Access Compliance Report

Public Rights-of-Way

Intersection ID: 11233	Main Street: FOXFORD_PL	Cross Street: TIPPERARY_PL	Location: NW
ADA ID: E9C8AF5858D8	Ramp Type: Para	Initial Pass/Fail: Fail	Overall Compliance: No
Severity Score: 33.75			
Codes/Mitigation Info/Possible Solution		Field Measurements/Component Compliance

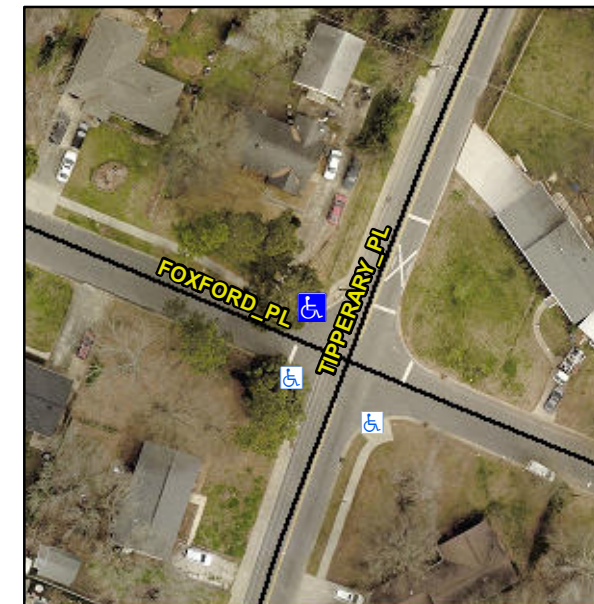
R304.5.1, R304.5.3, R304.3.2

Compliance	Description	Data	Compliance	Description	Data
N/A	Ramp Length LT (in)	19.5	N/A	Ramp Length RT (in)	16.5
No	Ramp Width LT (in)	47.0	No	Ramp Width RT (in)	47.0
Yes	Ramp Slope LT (%)	6.1	No	Ramp Slope RT (%)	11.1
No	Ramp XSlope LT (%)	6.7	No	Ramp XSlope RT (%)	5.2
N/A	Landing Length (in)	N/A	N/A	DWS Provided?	N/A
N/A	Landing Width (in)	N/A	N/A	DWS Contrast?	N/A
N/A	Landing Slope (%)	N/A	N/A	DWS Length (in)	N/A
N/A	Landing X Slope (%)	N/A	N/A	DWS Full Width?	N/A
N/A	Landing Curb? (Y/N)	N/A	N/A	DWS Offset (in)	N/A
N/A	Shared Landing?	N/A			
N/A	Gutter Ponding?	N/A	N/A	Gutter Slope (%)	N/A
N/A	Gutter Lip Ht (in)	1.0	N/A	Gutter X Slope (%)	N/A
N/A	Painted X Walk1?	No	N/A	Painted X Walk2?	N/A
	X Walk 1 Direction	To S		X Walk 2 Direction	N/A
N/A	X Walk 1 Width (in)	N/A	N/A	X Walk 2 Width (in)	N/A
	X Walk 1 Slope (%)	1.6		X Walk 2 Slope (%)	N/A
	X Walk 1 X Slope (%)	3.6		X Walk 2 X Slope (%)	N/A
N/A	Ramp inside XWalk1?	N/A	N/A	Ramp inside XWalk2?	N/A

Remove & Replace Entire Ramp.
